Our current supplier of Oil Furnace Direct Venting Kits, **Flex-L** has discontinued manufacturing the kits we purchase from them. We have secured a new supplier; NovaFlex will supply the Flexmaster **Z-Flex** brand **Oil Furnace Double Wall Insulated Direct Vent Kits**. We appreciate your patience during this transition period.

Figure 1. Flex-L Venting System

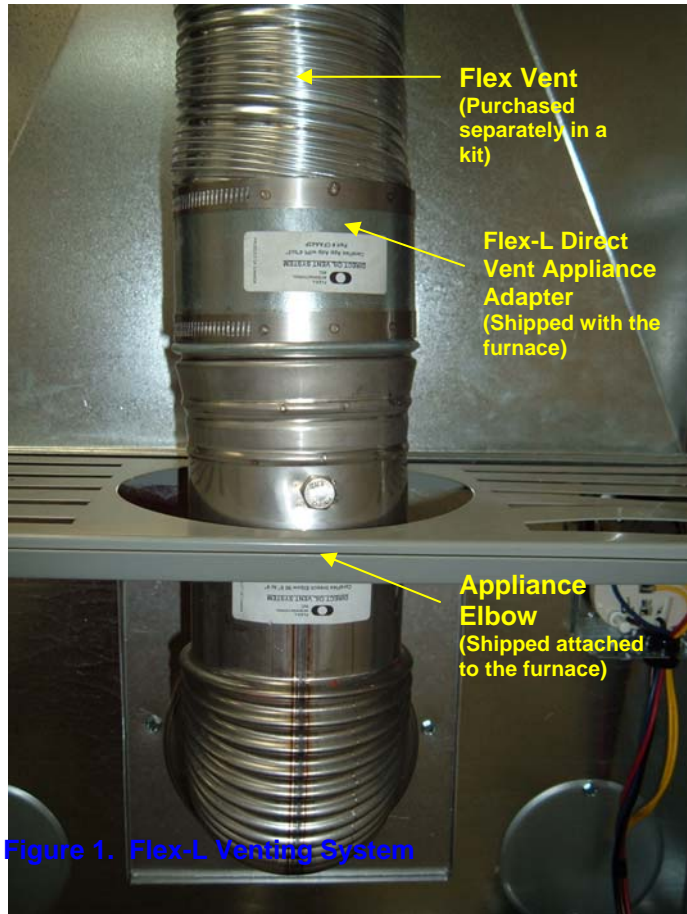
The two kits are **NOT** interchangeable. ECR supplies the Direct Vent Appliance Adaptor (Fig. 1 or 2) with every Direct Vent Oil Furnace manufactured. If the Direct Vent Oil Furnace has a **Flex-L** appliance adaptor inside (Fig. 1) a **Flex-L** vent kit must be used. If the furnace has a **Z-Flex** appliance adaptor inside (Fig 2.) a **Z-Flex** vent kit must be used.

The **Flex-L** flex vent (Fig 1.) attaches to the appliance adaptor and termination adaptor in a clockwise motion. The **Z-Flex** direct vent appliance adaptor (Fig. 2) and termination adaptor attach in a counter clockwise motion.
